SS 581860 FCCC 15 Gallon DEF Header Service Replacement Additional Parts (299)

Original SSI DEF Header, which has been discontinued, has failed and needs to be replaced. Replacement KUS DEF header must be used as replacement, but MAY require additional parts and re-routing of DEF Coolant lines and DEF lines to the new KUS DEF header 04-37616-000.

SSI TO KUS COMPARSION (15GAL DEF SYSTEM)

TYPE 5

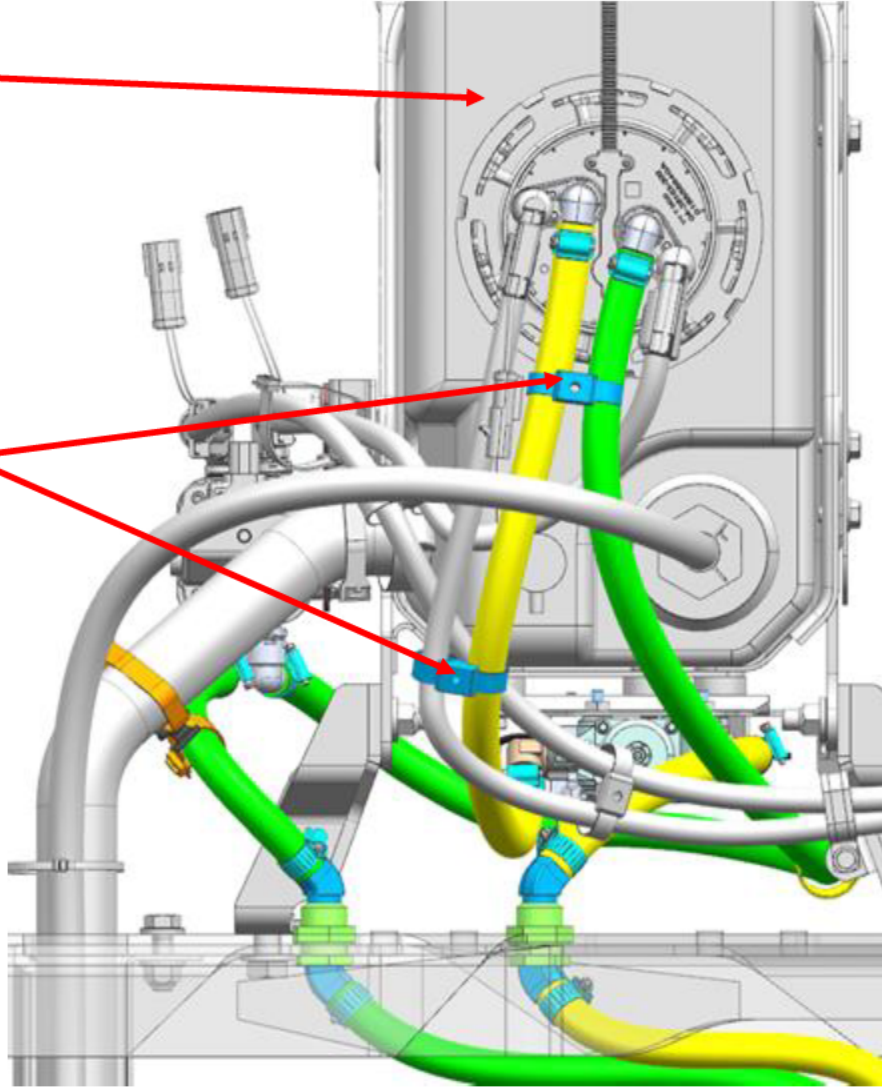
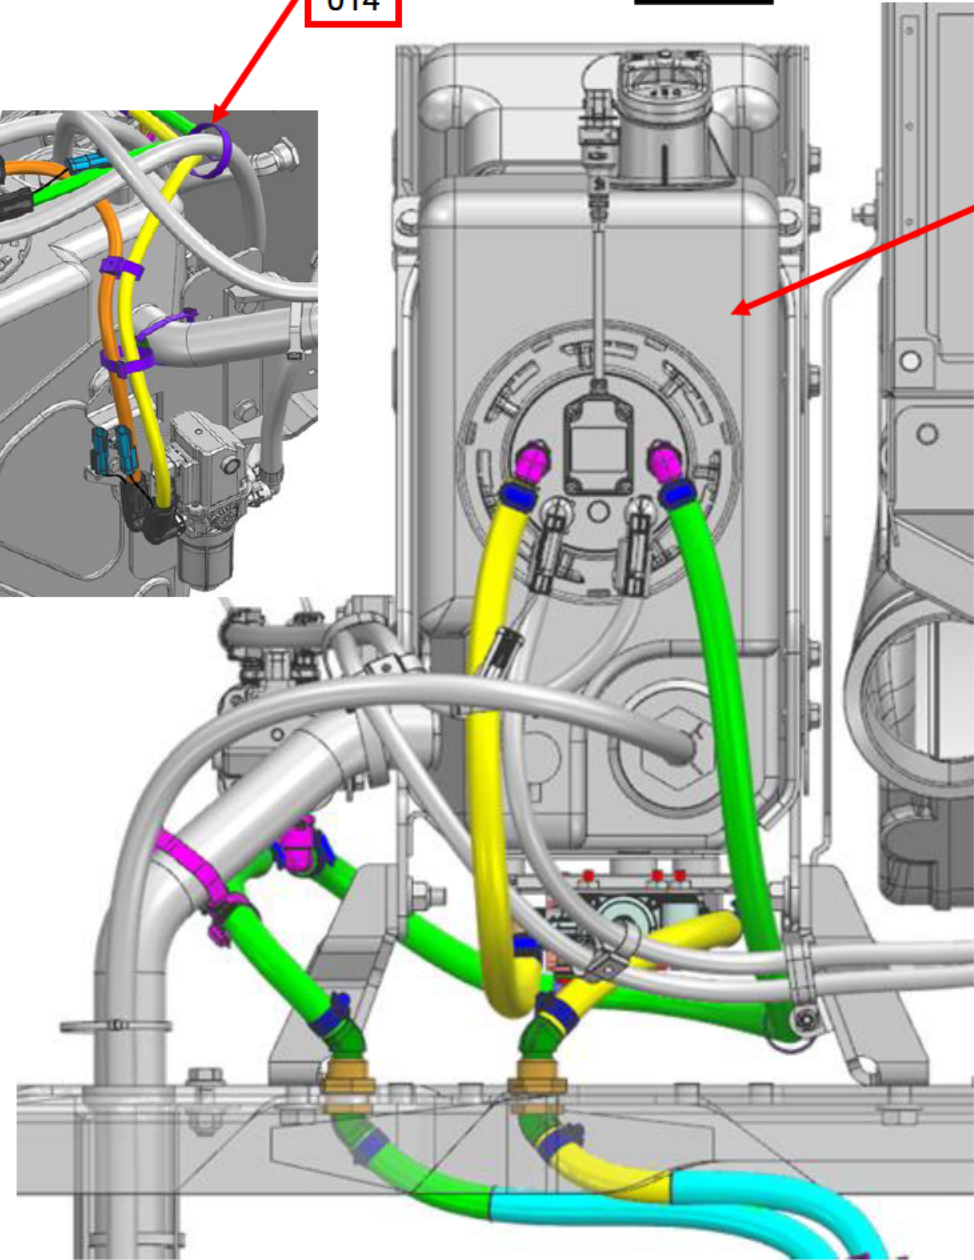
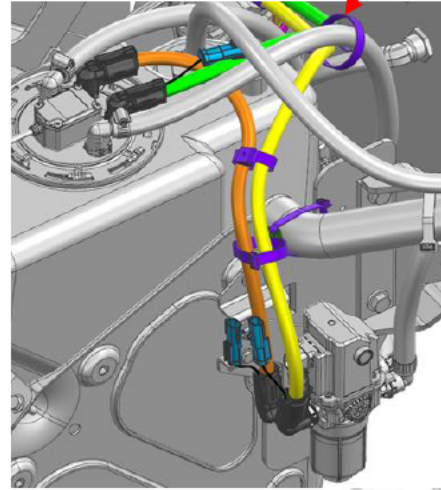
Required parts to KUS

DEF SYSTEM		SSI			KUS		
MOD	DESCRIPTION	ITEM NUMBER	ITEM	QTY	ITEM NUMBER	ITEM	QTY
23U	BILL	-	23U-C06205	-	*	23U-C06241	
	PARTS	001	A04-36022-000	1	001	A04-37438-000	1
23V	BILL	-	23V-C05529	-	-	23V-C05567	-
	INSTALL	-	D04-35705-000	-	-	D04-37529-000	-
	PARTS	007	TYCDCT110HIR	2	-	-	-
23W	BILL	-	23W-C00393	-	-	23W-C14106	-
	INSTALL	-	D04-35684-000	-	-	D04-37552-000	-
	PARTS	-	-	-	014	23-13476-000	1

TYPE 6

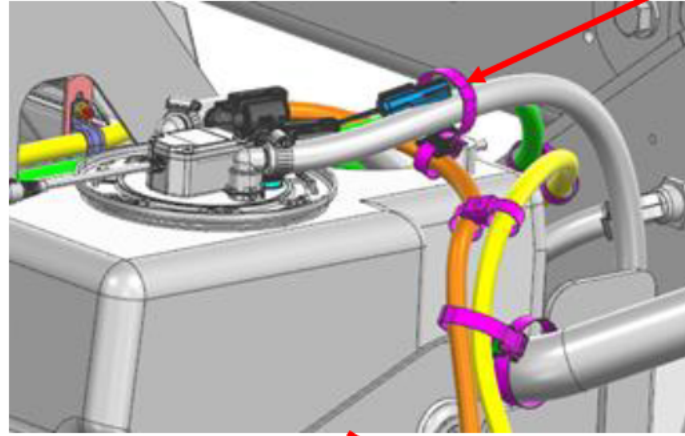
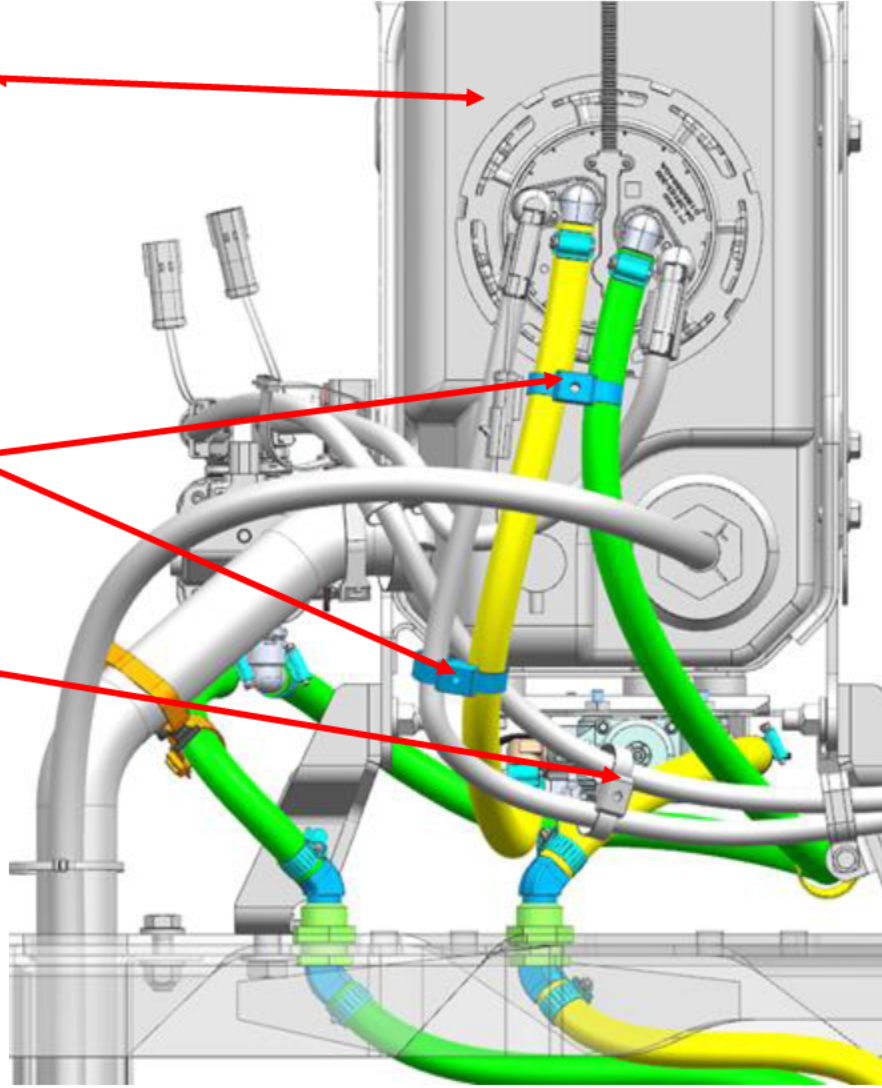
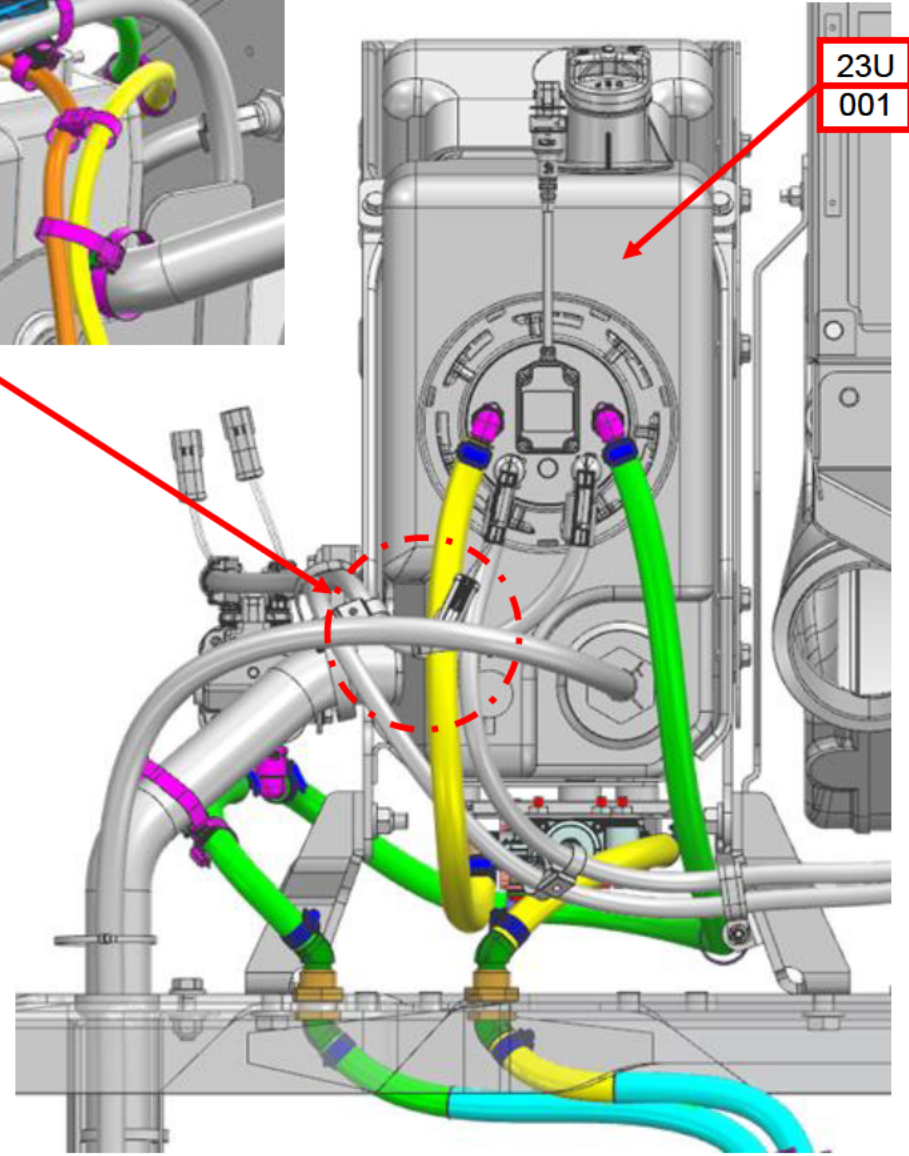
Required parts to KUS

DEF SYSTEM		SSI			KUS			
MOD	DESCRIPTION	ITEM NUMBER	ITEM	QTY	ITEM NUMBER	ITEM	QTY	
23U	BILL	-	23U-C06205	-	-	23U-C06241	-	
	PARTS	001	A04-36022-000	1	001	A04-37438-000	1	
23V	BILL	-	23V-C05529	-	-	23V-C05567	-	
	INSTALL	-	D04-35705-000	-	-	D04-37529-000	-	
	PARTS	007	TYCDCT110HIR	2	-	-	-	
23W	BILL	-	23W-C00395	-	-	23W-C14107	-	
	INSTALL	-	D04-36159-000	-	-	D04-37553-000	-	
	PARTS	005	TYCDCT110HIR	1	-	-	-	
		-	-	-	-	004	23-12886-001	1
		-	-	-	-	006	23-13476-000	2

TYPE 7 SSI

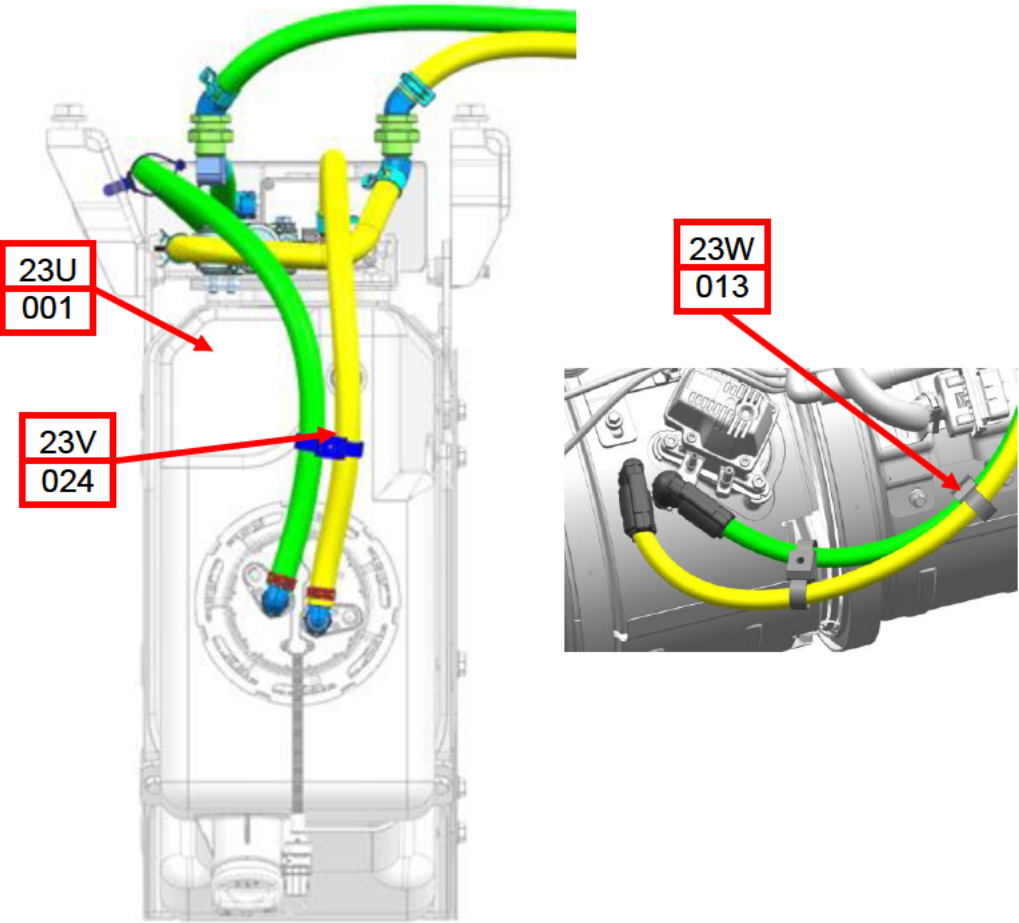
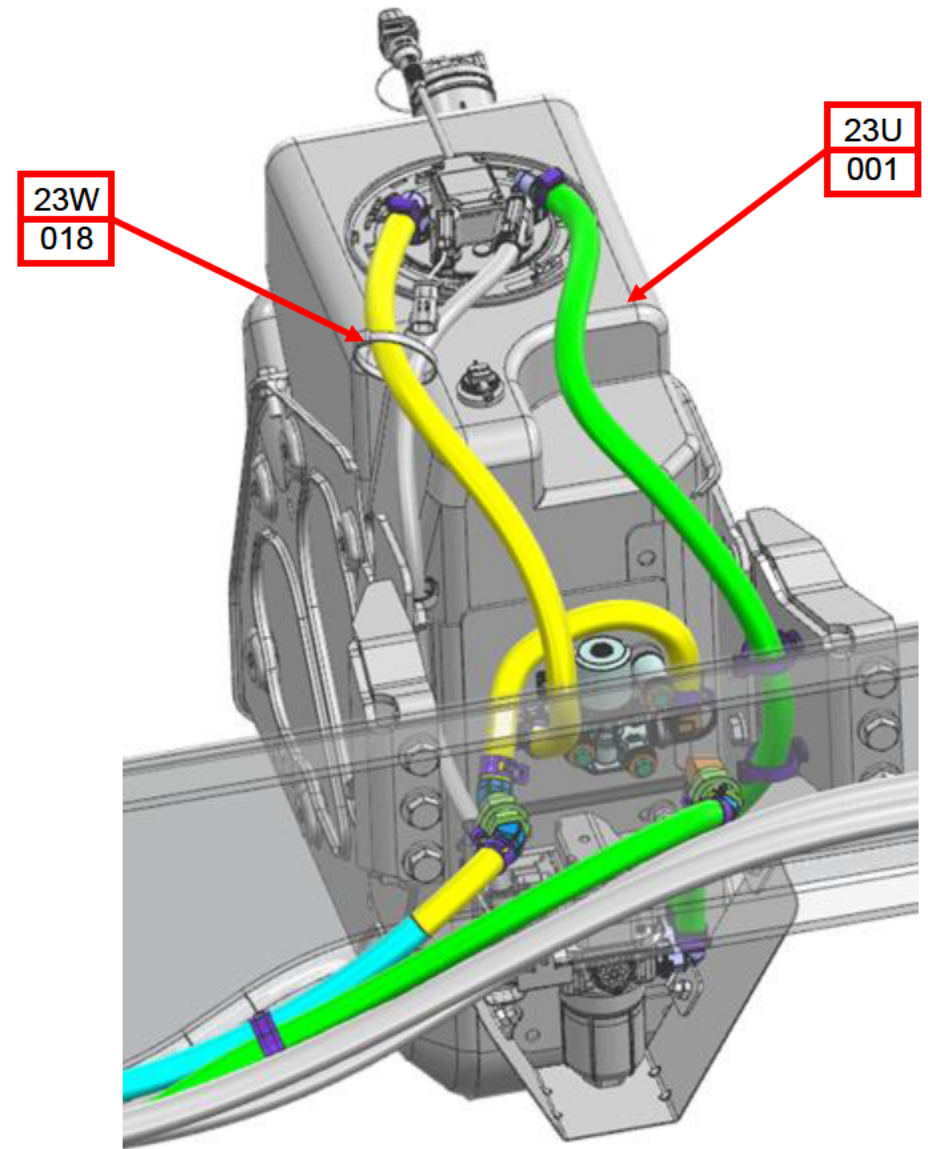
Required parts to KUS

DEF SYSTEM		SSI			KUS		
MOD	DESCRIPTION	ITEM NUMBER	ITEM	QTY	ITEM NUMBER	ITEM	QTY
23U	BILL	-	23U-C06206	-	-	23U-C06242	-
	PARTS	001	A04-36023-000	1	001	A04-37439-000	1
23V	BILL	-	23V-C05526	-	-	23V-C05566	-
	INSTALL	-	D04-35559-000	-	-	D04-37528-000	-
	PARTS	024	TYCDCT110HIR	1	-	-	-
23W	BILL	-	23W-C00374	-	-	23W-C14101	-
	INSTALL	-	D04-35627-000	-	-	D04-37546-000	-
	PARTS	013	TYCDCT110HIR	1	-	-	-
		-	-	-	-	018	23-09796-629

TYPE 8

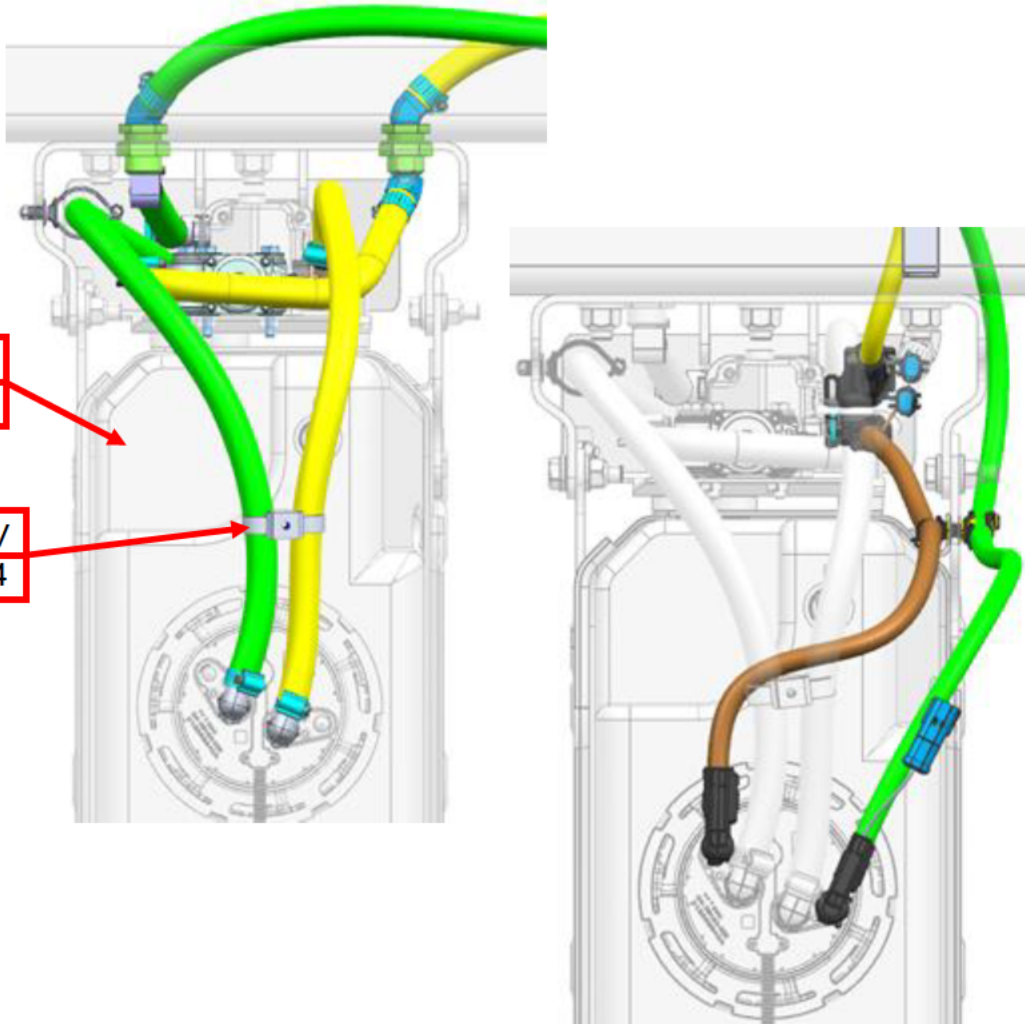
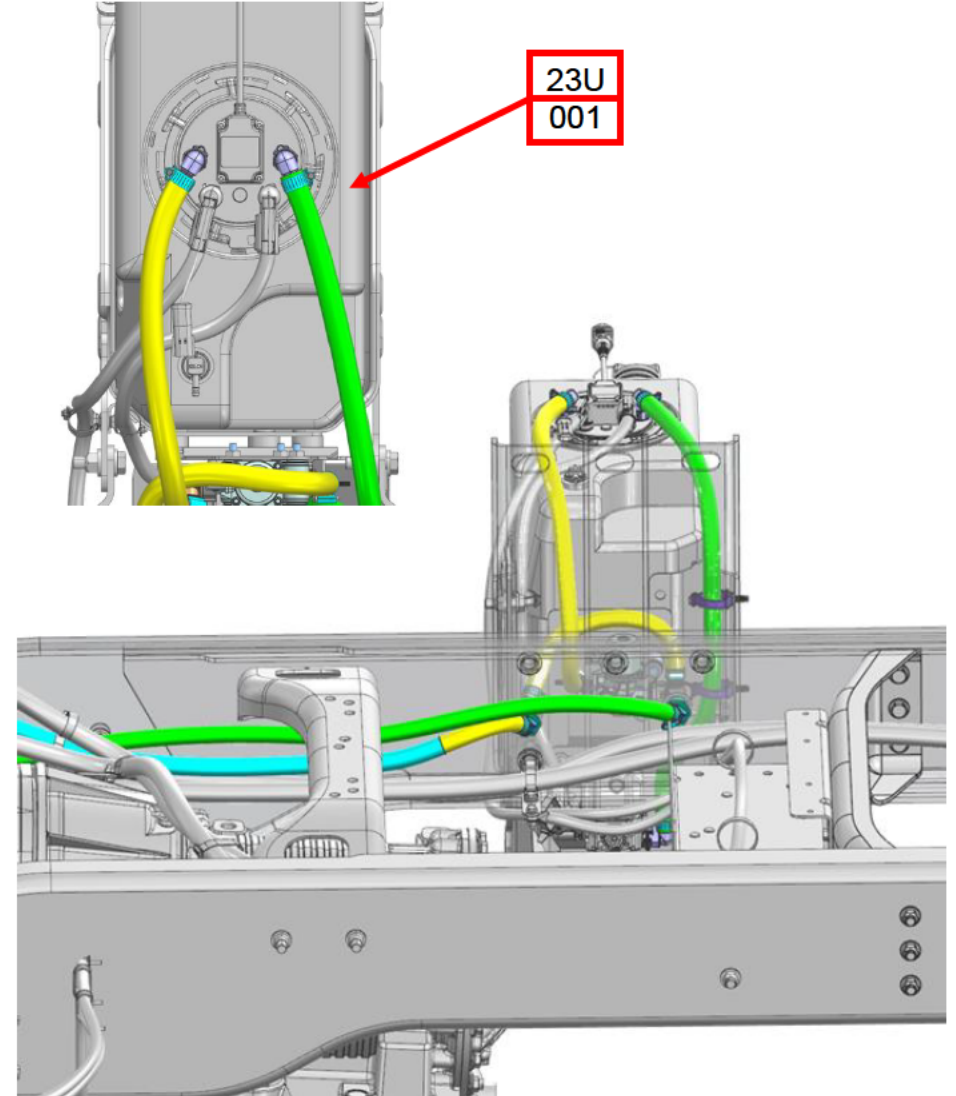
Required parts to KUS

DEF SYSTEM		SSI			KUS		
MOD	DESCRIPTION	ITEM NUMBER	ITEM	QTY	ITEM NUMBER	ITEM	QTY
23U	BILL	-	23U-C06207	-	-	23U-C06243	-
	PARTS	001	A04-36023-000	1	001	A04-37439-000	1
23V	BILL	-	23V-C05530	-	-	23V-C05568	-
	INSTALL	-	D04-35717-000	-	-	D04-37530-000	-
	PARTS	024	TYCDCT110HIR	1	-	-	-
23W	BILL	-	23W-C00380	-	-	23W-C14102	-
	INSTALL	-	D04-35620-000	-	-	D04-37544-000	-

TYPE 9

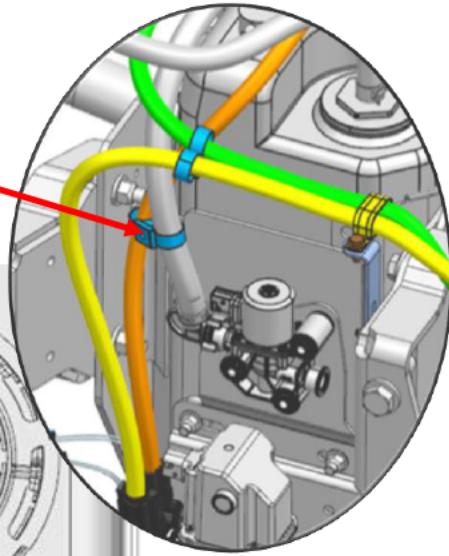
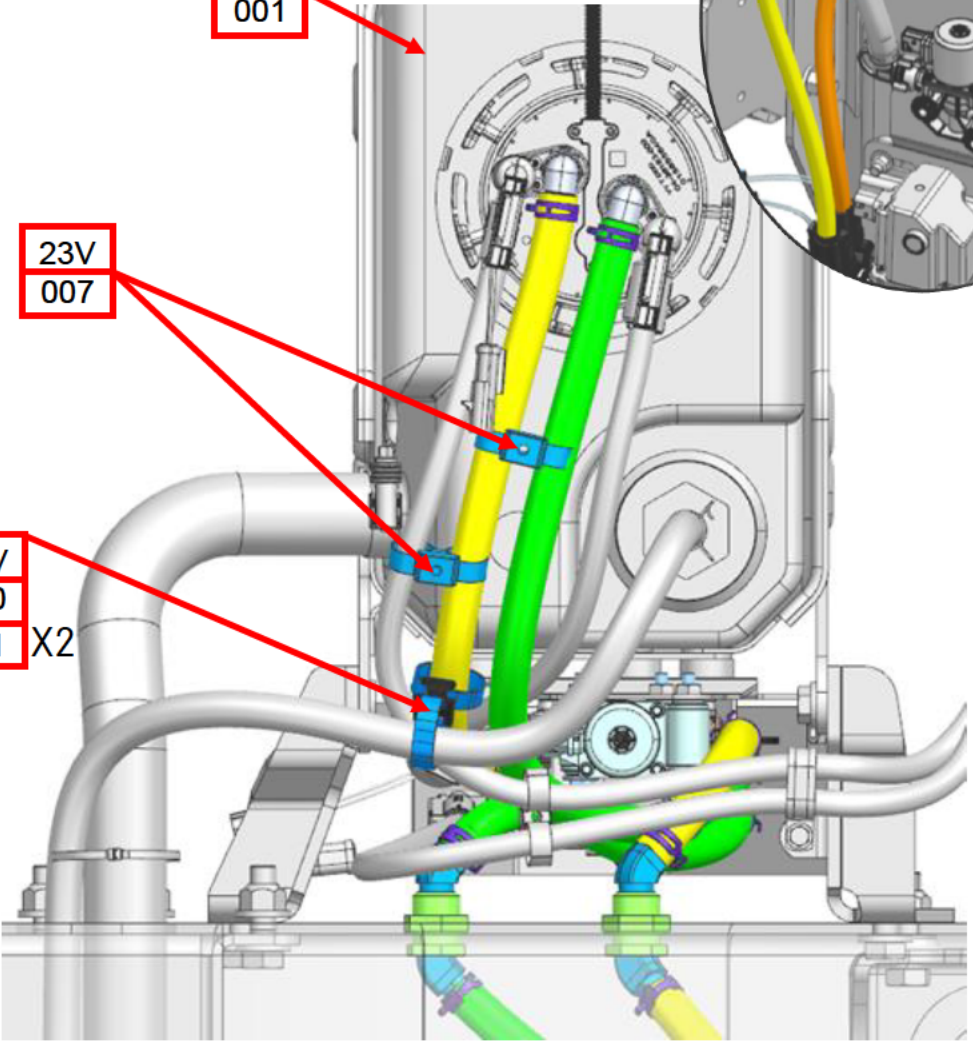
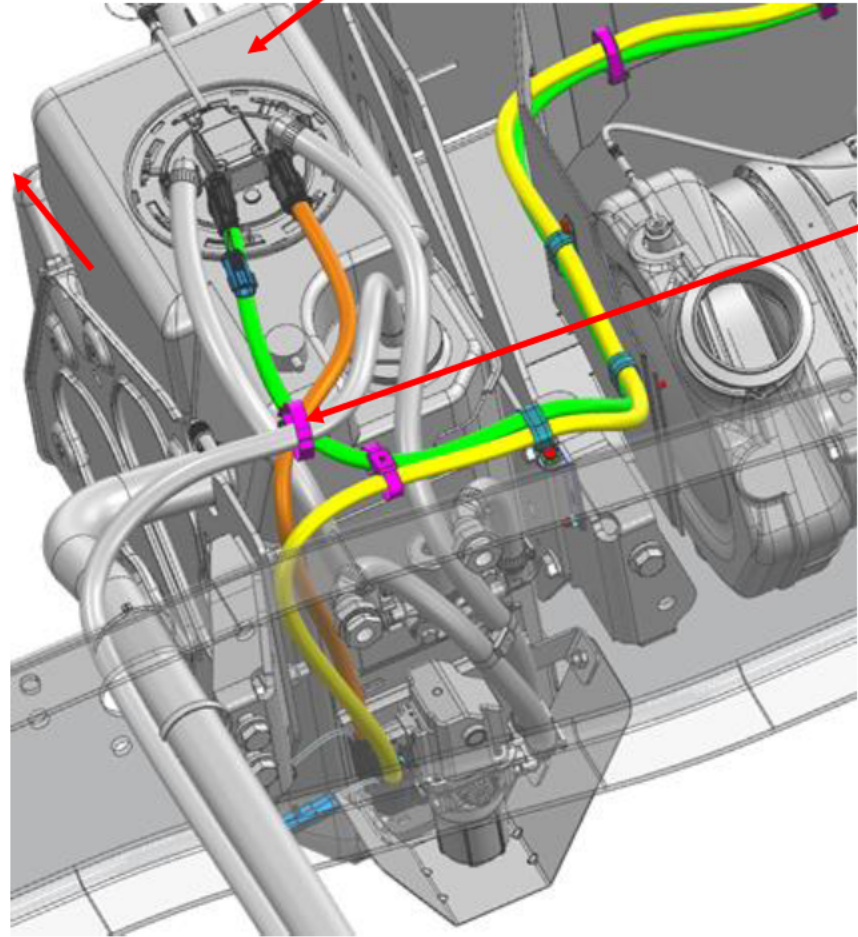
Required parts to KUS

DEF SYSTEM		SSI			KUS			
MOD	DESCRIPTION	ITEM NUMBER	ITEM	QTY	ITEM NUMBER	ITEM	QTY	
23U	BILL	-	23U-C06212	-	-	23U-C06246	-	
	PARTS	001	A04-36022-000	1	001	A04-37438-000	1	
23V	BILL	-	23V-C05541	-	-	23V-C05572	-	
	INSTALL	-	D04-36214-000	-	-	D04-37534-000	-	
	PARTS	007	TYCDCT110HIR	2	-	-	-	
		010	23-12886-001	1	-	-	-	
		011	23-13476-000	2	-	-	-	
23W	BILL	-	23W-C00396	-	-	23W-C14108	-	
	INSTALL	-	D04-36220-000	-	-	D04-37554-000	-	
	PARTS	-	-	-	-	005	23-13476-000	2
		-	-	-	-	014	23-12886-001	1
		007	TYCDCT110HIR	1	-	-	-
